Montauk

MONTAUK: 421

SUITE 421
INVENTORY SUITE

CLIENT: ROYAL PINE HOMES

Inventory Suite

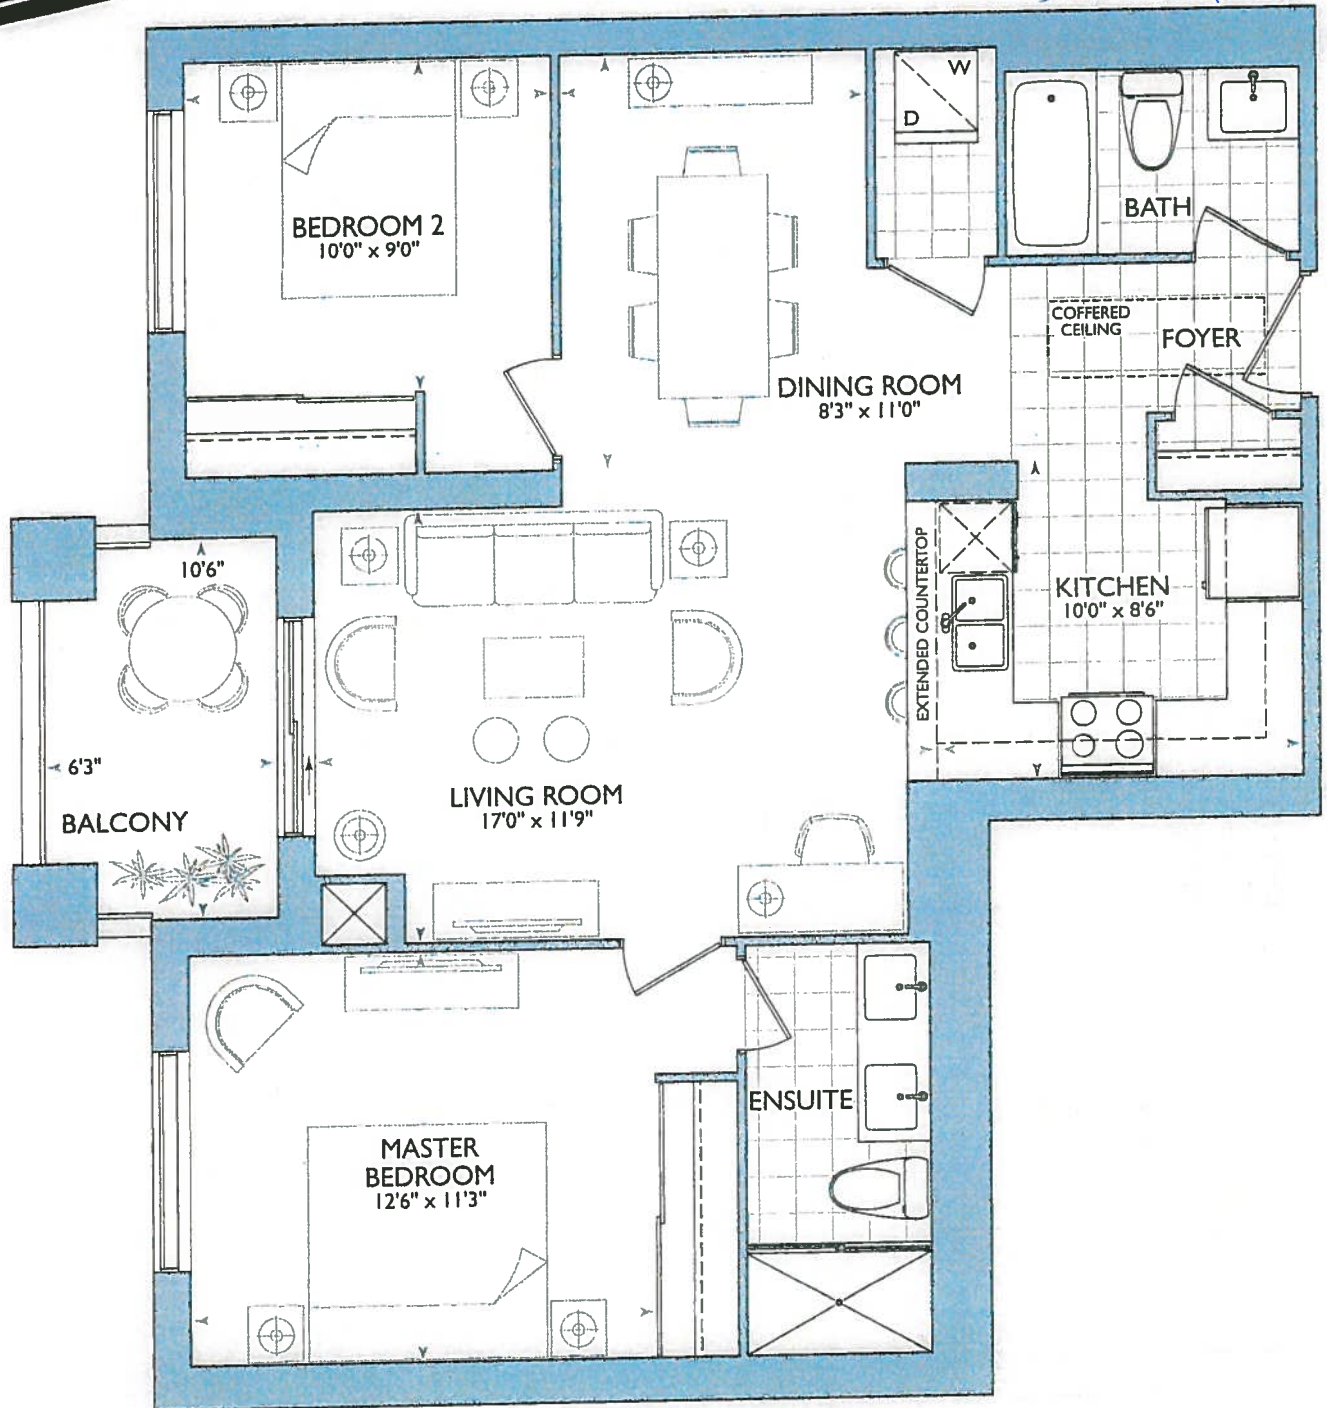
- NEW LOCATION SECURITY PANEL RELOCATE AT MAIN BATH WALL
- 6" COFFERED CEILING AS PER ORIGINAL BROCHURE

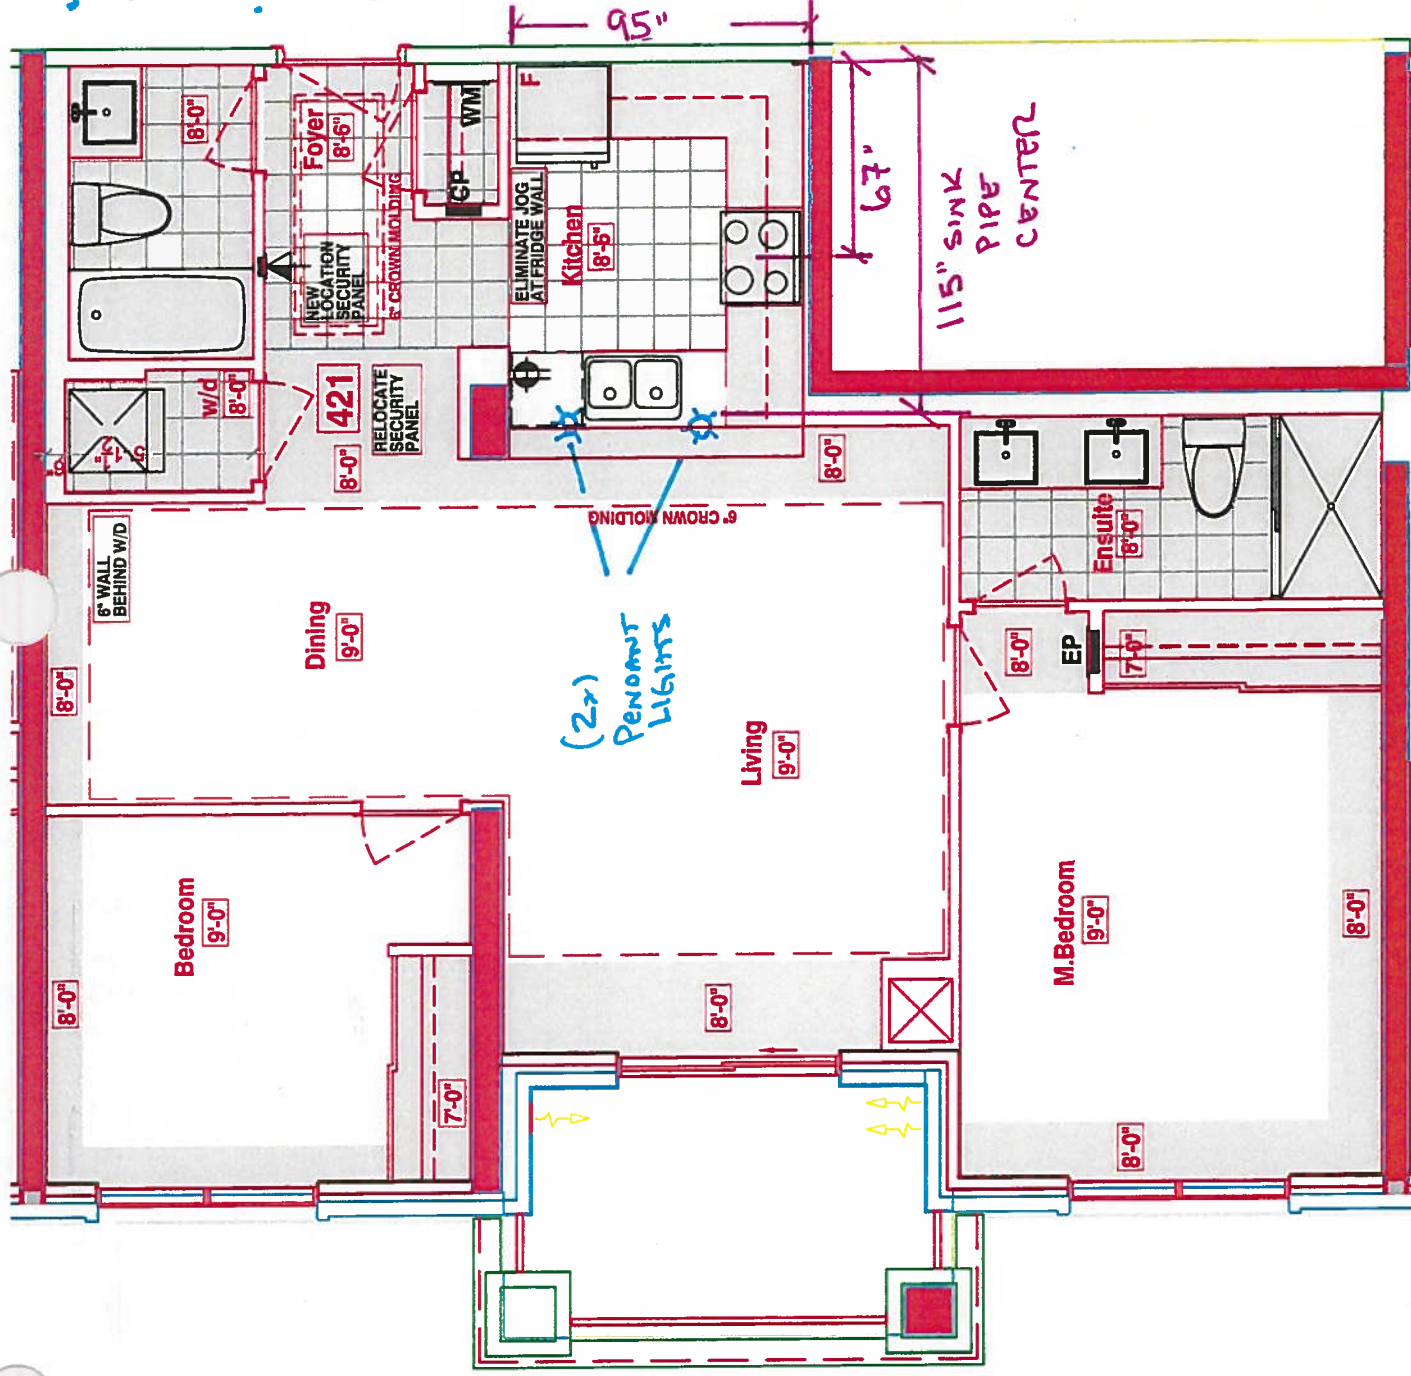
- OPTION OF USING STD KITCHEN LAYOUT W/ STD APPLIANCE PACKAGE
- OR
- 1ST UPGR. KIT. LAYOUT W/ 1ST UPGR. APPLIANCE PACKAGE (SEE BOTH KITCHEN OPTIONS)

- (P) = PLUG PENINSULA
- 2x = LIGHTS OVER PENINSULA
- 67" STOVE PIPE CENTER
- 115" SINK PIPE CENTER
